Ref: 20100623-turbines
Date: 23 June 2010

WIND TURBINE WAKE PLUME
VELOCITY DEFICIT AND TURBULENCE

As per our latest telephone conversation I agreed to write a letter that you can present to the Victorian Review Panel handling the Stockyard Hill Wind Farm Application Number PL-SP/05/0548.

**Beaufort (Hawkwood)
YBFT**

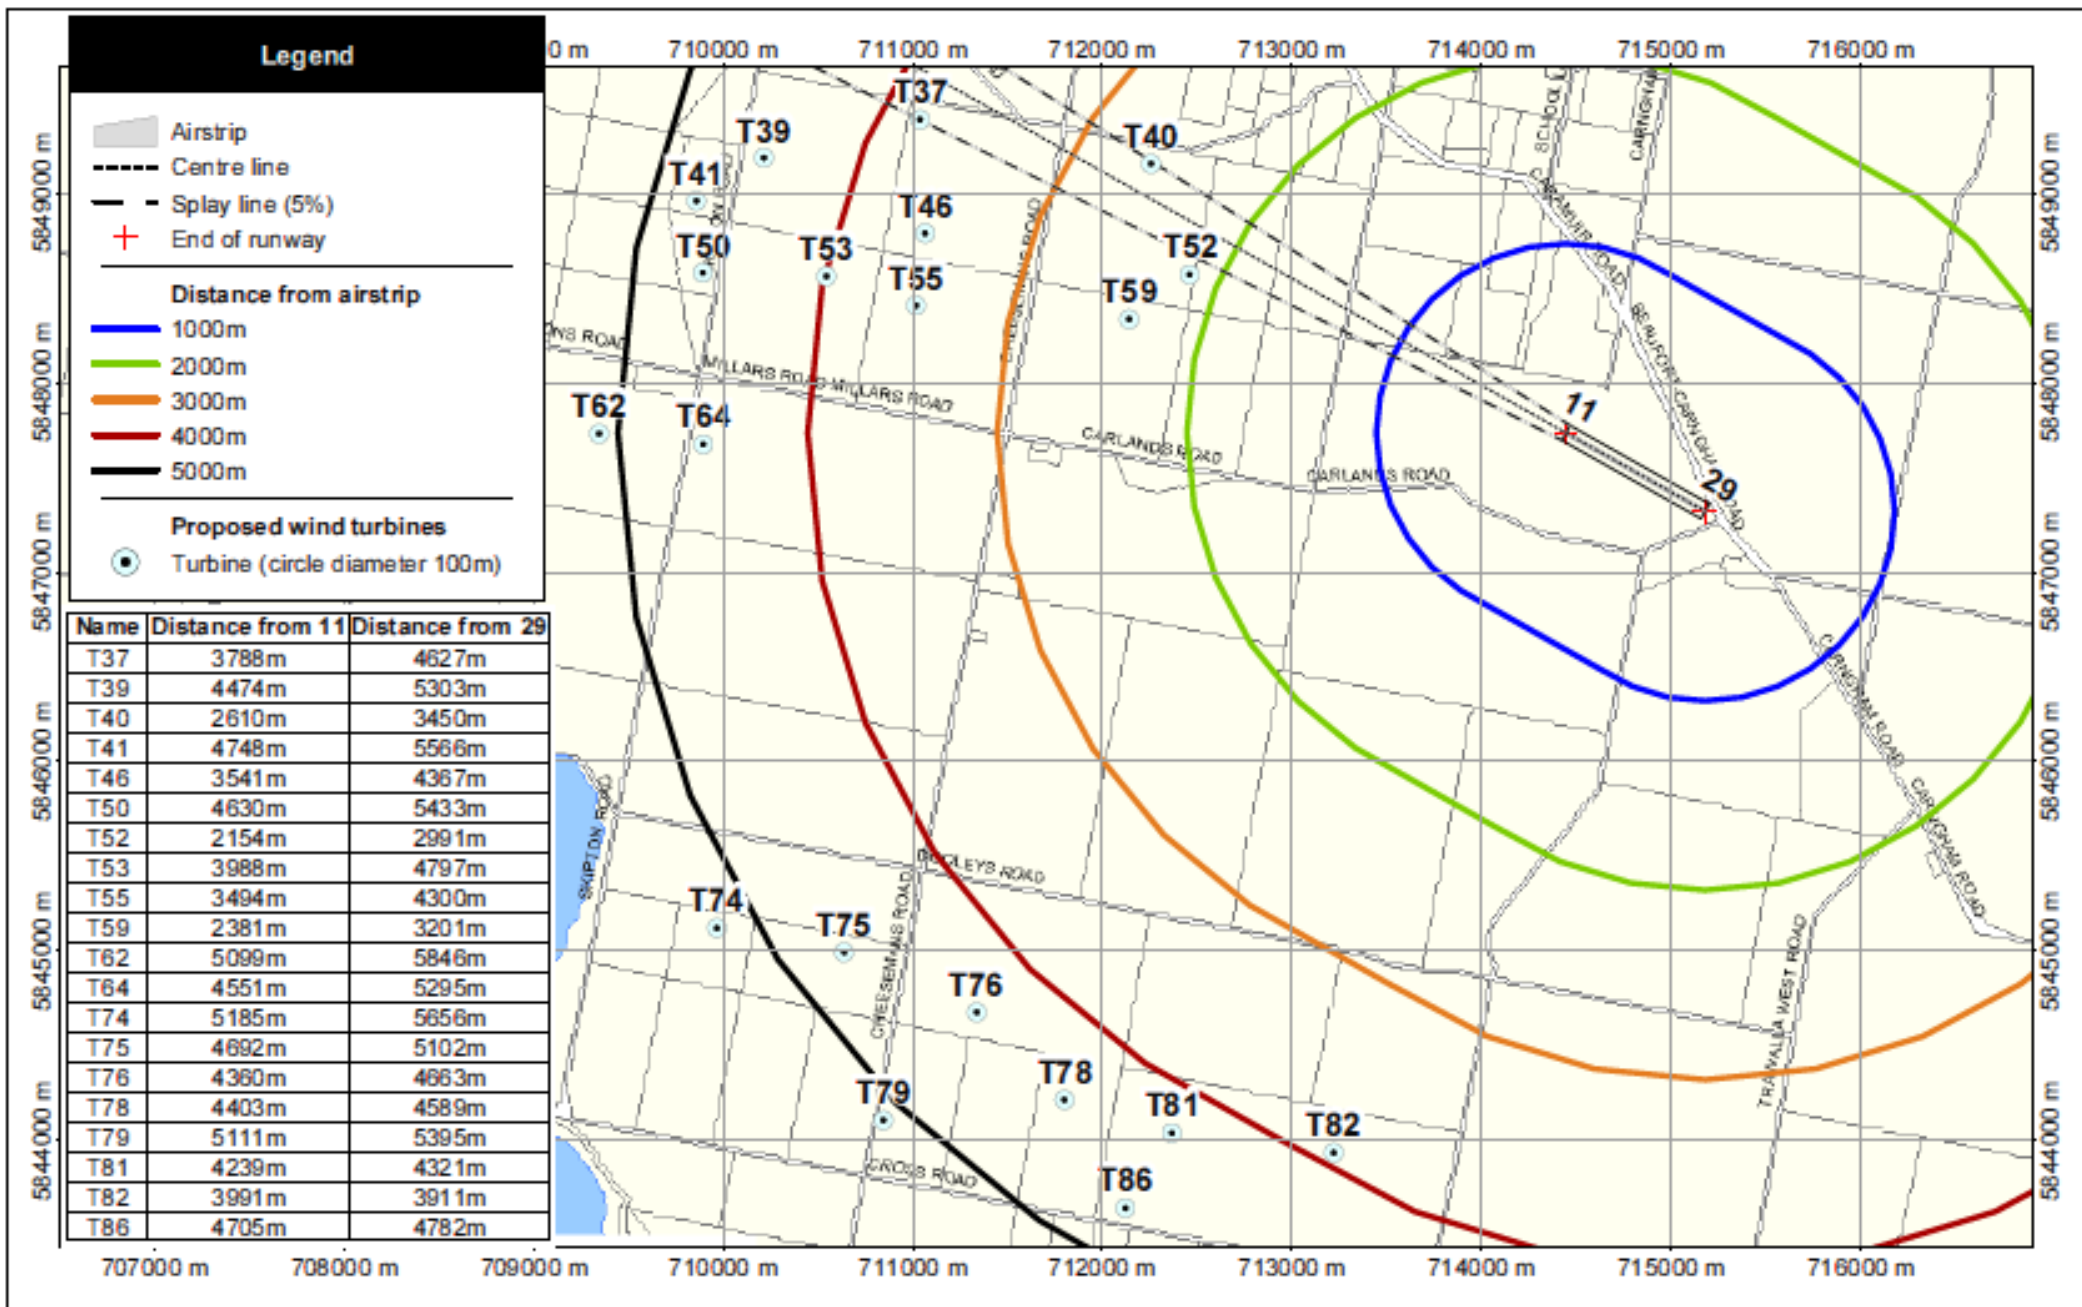
To assist with my analysis you provided me with a map detailing your ALA which included the location of the closest 20 turbines and distance arcs from your runway thresholds – which I will call the operational area map (Ref 8). This map is marked as Beaufort (Hawkwood) YBFT. I also sourced data from the Stockyard Hill Wind Farm Pty Limited website <http://www.stockyardhillwindfarm.com.au>, and it was determined that the proponent's submission involves turbines with a blade tip diameter of 104 metres.

With the information supplied from you that the strongest prevailing winds are typically from the North West, West and South West directions, and then surveying the turbine proposed locations on your operational area map, I can see two clusters of turbines that will directly affect your ALA operational area to varying degrees of extent, namely the clusters : T40, T52, T59, T37, T46, T55, T53, T39, T41, T50, T64 and T62 for direct take-off and landing, and clusters: T75, T76, T78, T81, T82, T74, T79 and T86 which will affect crosswind operations.

Thus I would argue for an operational area of 4920 meter radius from the runway threshold for Category B aircraft and a setback of turbines from this operational area of 50 blade diameters. This represents an additional 5200 meters for turbines with the proposed 104 metres blade-tip diameter.
